Objection from Residents of 3 Britannia Street to the proposed development of Rear Of 1-3, Britannia Street, London, WC1X 9BN (ref: 2016/6356/P0)

Exhibit 1.1 from (see p43 on Daylight and Sunlight Report)

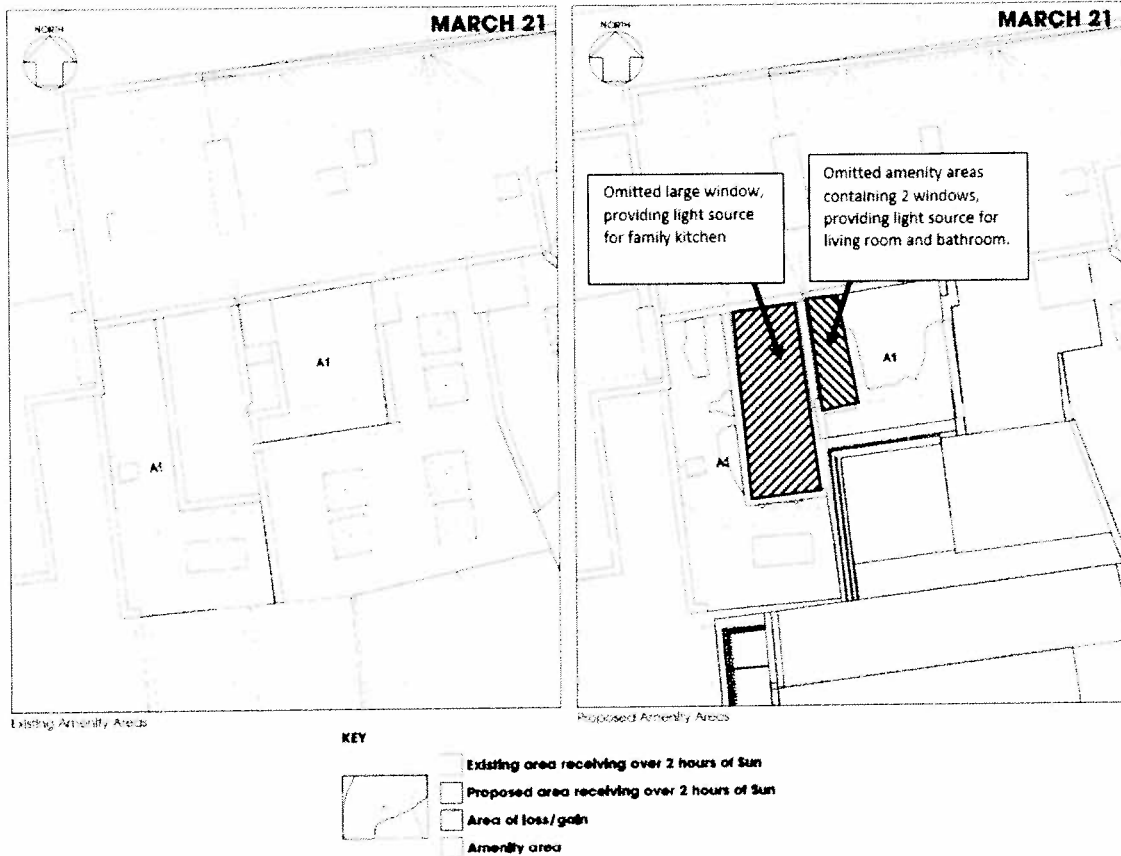
- For 3 Britannia Street a ground floor amenity area containing **two windows has been completely left off the Daylight and Sunlight report**, both for windows measurement and amenity areas. This area is clearly visible and it is inexcusable that it has been left off the report.
- The Amenity area is the **only outdoor area for the ground floor flat of 3 Britannia Street**.
- The two windows that are missing from the report are important to us. One is the only source of light for a bathroom and the other, more importantly, one is the only source of light for a living room for flat the below excepted from the Daylight and Sunlight Report has been edited to show the relevant missing areas.

- For instance, applying the area loss and gain to A1 on the above diagram would mean that substantial daylight hours loss to the omitted amenity area. This would, with high certainty, that the proportion receiving at least 2 hour of sun on 21 March would fall below BRE target of 50%, given it is currently at a marginal rating of only 52%. Similarly, for 5 Britannia Street, given that most of the amenity area will lose light (only 9% with 2 hours of daylight), down from a large majority that the missing window would fall far below BRE requirements.

- New Daylight and Sunlight Report commissioned by Council planner recommended consultant:** The existing Daylight and Sunlight Report is incorrect to the extent of being negligent. We propose that a new report be commissioned, that accounts for all windows and amenity areas. Additionally, the developers have shown themselves unable to select a competent and/or unbiased Daylight and Sunlight consultant, as illustrated by the poor quality and numerous mistakes within the report. We propose that the Daylight and Sunlight consultant be chosen by the community or by the council planners.

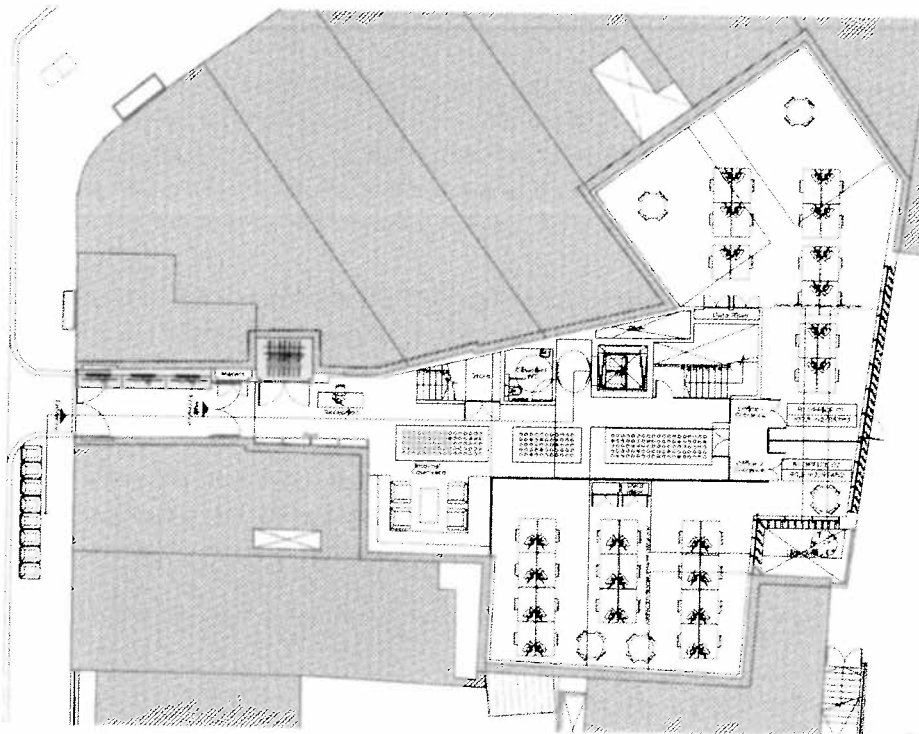
- The below diagram shows that for waste disposal 8 x 240 litre bins will be placed in front of 3 and 5 Britannia Street.

- While the DAS suggests that these will be placed on the street on the day of waste disposal and removed thereafter, they provide no plans or measure on how this is to be accomplished suggesting lack of research and knowledge of the surrounding area.

- Rubbish on Britannia Street is collected 3 times a week on Monday, Wednesdays and Fridays. It is typically collected early in the morning normally before office hours. This means the new development would have to leave 8 bins in front of our property of 3 Britannia Street from the close of business (17.00) until opening of business (9.00am) the next day.

- This means that rubbish will be amassed in front of our property for at least 16 hours three times a week, creating a potentially unsafe environment for residents, especially for children.

- **Secure off street storage for collection with private collection:** The reasonable solution is for the development to plan to store waste from collection within their property, as opposed to on the street, and either have private waste collection recover it from there.
